# TECH-NIQUE

S-240

December 6, 1973

SUBJECT: CHIEF 23 - CB/VHF UNIT

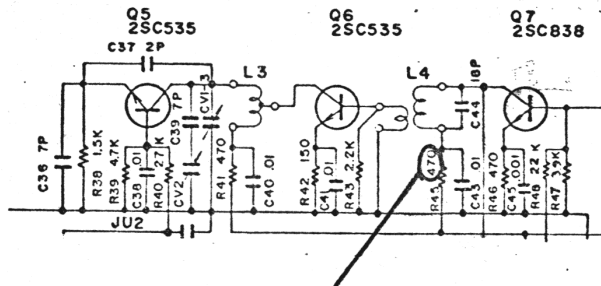
To improve sensitivity in the VHF section in early production resistor R45 (470 ohm) with a 68 or 82 ohm 1/4w resistor.  
Resistor R45 is located near coil L4.

Replace with 68 or 82 ohm 1/4w.
